COUNCIL ASSESSMENT REPORT

Panel Reference	2018SWC028
DA Number	DA 1235/2018/JP
LGA	The Hills Shire Council
Proposed Development	Construction of four 6 - 25 storey residential flat buildings comprising 290 units, a neighbourhood shop and four levels of basement car parking
Street Address	Lot 1 DP 866565 7 Maitland Place, Bella Vista
Applicant/Owner	7 Norwest Pty Ltd
Consultants	Dowling Urban Pty Ltd Craig & Rhodes Turner Arcadia Efficient Living Renzo Tonin Vista Access Architects Naturally Trees Norman, Disney and Young JHA Services Eco Logical Australia EI Australia AT & L Traffix Elephants Foot CPP
Date of DA lodgement	21 December 2017
Number of Submissions	Seven
Recommendation	Approval
Regional Development Criteria (Schedule 7 of the SEPP (State and Regional Development) 2011	CIV exceeding \$30 million (\$138,206,735)
List of all relevant s4.15(1)(a) matters	<ul style="list-style-type: none"> • State Environmental Planning Policy (State and Regional Development) 2011 • State Environmental Planning Policy No. 65 – Design Quality of Residential Flat Development • State Environmental Planning Policy Infrastructure 2008 • State Environmental Planning Policy No 55 — Remediation of L

Figure 3: Building Massing Study presented to the Design Excellence Panel on 11 July 2018.

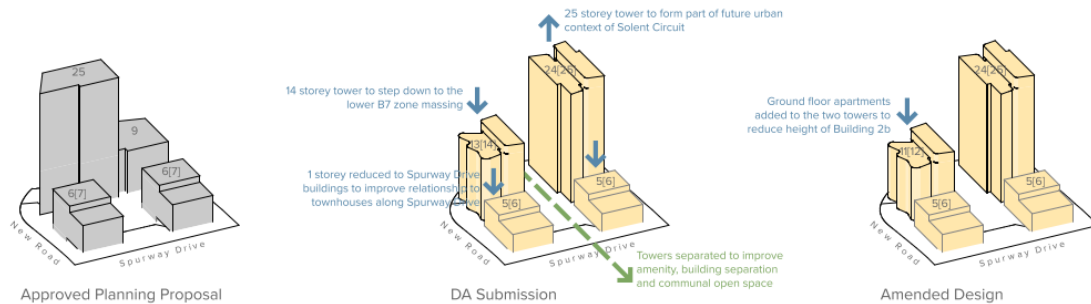
The Panel concluded that it is “yet to be convinced that the proposed built form massing is improving design quality and recommends that further study is undertaken to retain the tallest element within the eastern portion of the site, consistent with the massing in the planning proposal”. The Panel also considered that as the development is to be particularly significant in shaping the future character and amenity of a denser, taller and more urbanised Hills Shire, the distances between the tall buildings should be substantially more than the Apartment Design Guide minimums. It was suggested that the proposal be reconsidered to address this matter and returned to the Panel for further discussion.

Figure 5: Urban Massing Study presented to the Design Excellence Panel on 10 October 2018.

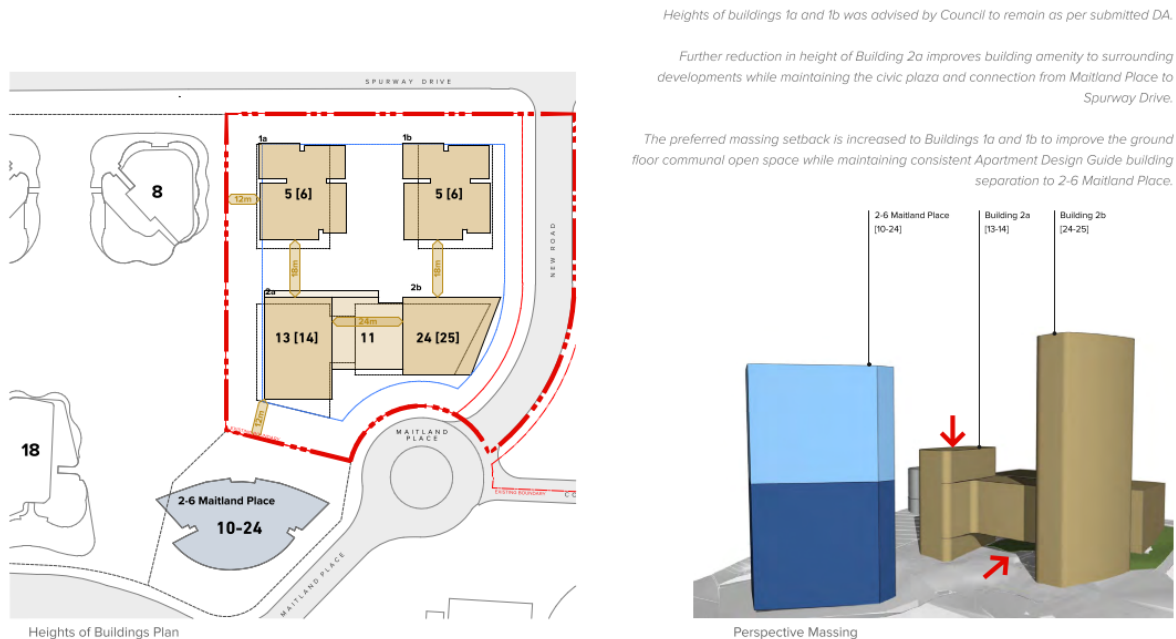
Three scenarios were presented at the Design Excellence Panel meeting demonstrating how the recommended built form and height allocation across the site had been achieved. The “preferred massing option” as indicated in the figure above was more consistent with the planning proposal. This option included the tallest tower (25 storeys) being relocated to the south east and the building to the south west was lowered to 14 storeys. An 11 storey link between the southern towers was also proposed. The two buildings on Spurway Drive remain unchanged at 5/6 storeys. The Panel indicated support of the general direction of the revised massing and arrangement of the building blocks but recommended the applicant present a revised DA with detailed drawings and documentation to the Panel.

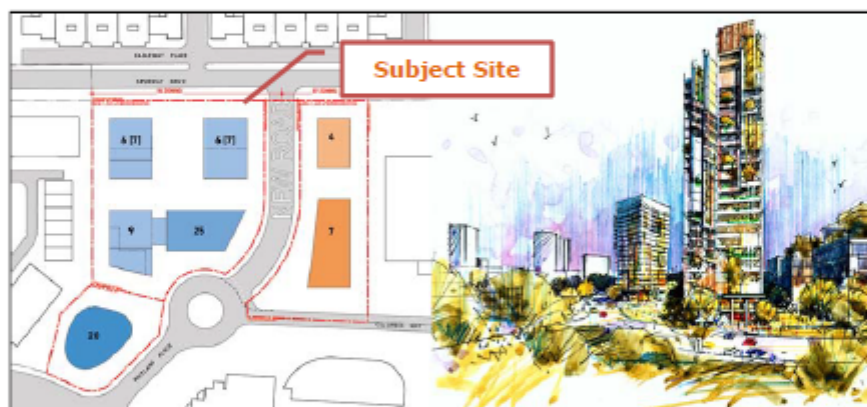
1. The applicant confirmed the Development Application for the civil works and new road was close to being submitted, (including the subdivision plan). Note: this is a requirement of the VPA.
2. The applicant confirmed the GFA calculations excluded the area of the proposed road to be dedicated to Council.
3. SEPP 65 items to be clarified and or amended:
 - The Panel suggested that the extent of communal open space at both ground level and roof top be accurately defined on the drawings including ADG solar

access compliance. Note: setback areas should not be included as part of the communal open space.

- The Panel requested that the hourly increments between the hours of 9am and 3pm of the built form solar views be provided.
 - Building separation between the 6 storey buildings 1a + 1b and the taller buildings 2a + 2b do not appear to strictly comply with ADG guidelines and that some changes to the bedroom fenestration is required to be acceptable. Recommendations included for blocks 1a + 1b to re-plan affected master bedrooms to corners to overlook the street and courtyard, to provide an angled window to the second bedrooms so that direct sightlines across to buildings 2a + 2b are avoided.

- The applicant advised that the development complies with ADG Solar Access requirements to private living areas for each building and as an overall development.
